STATUS OF CLAIMS

REMARKS

In the Drawings:

FIG. 3

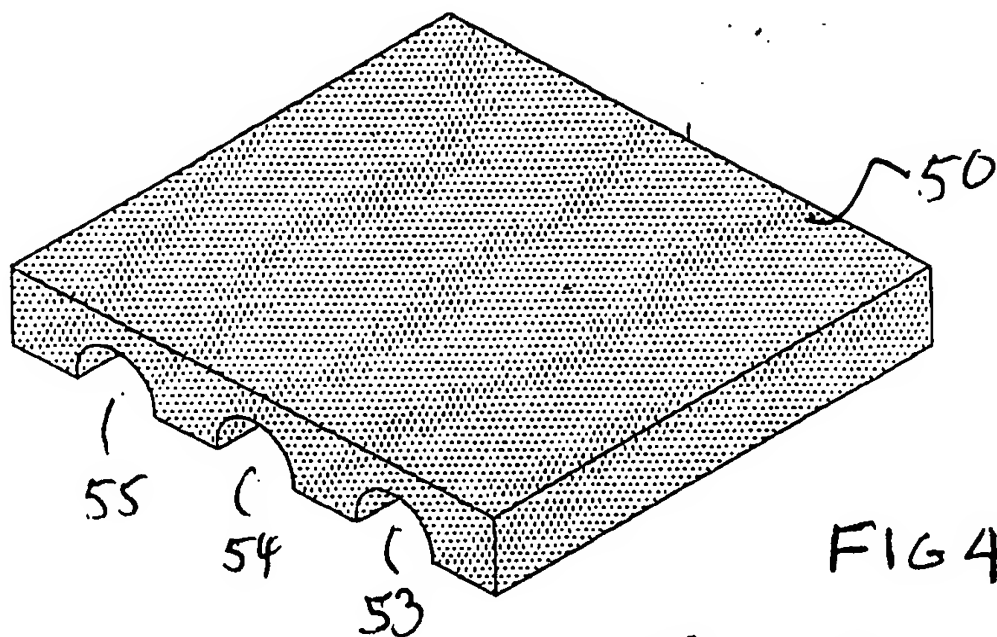
The drawings stand objected to as failing to comply with 37 CFR 1.84(p)(4) because reference characters "41" and "45" have both been used to designate the same micropipe in Figure 3. Applicant has amended Figure 3 without prejudice herein to omit reference character 41.

In Figure 3, reference character 41 has been omitted. In Figures 4A – 4C, reference characters 50 – 55, 53A – 55A and 60 have been omitted. In Figure 8C, reference character 98 has been omitted. In Figure 9C reference character 111 has been omitted.
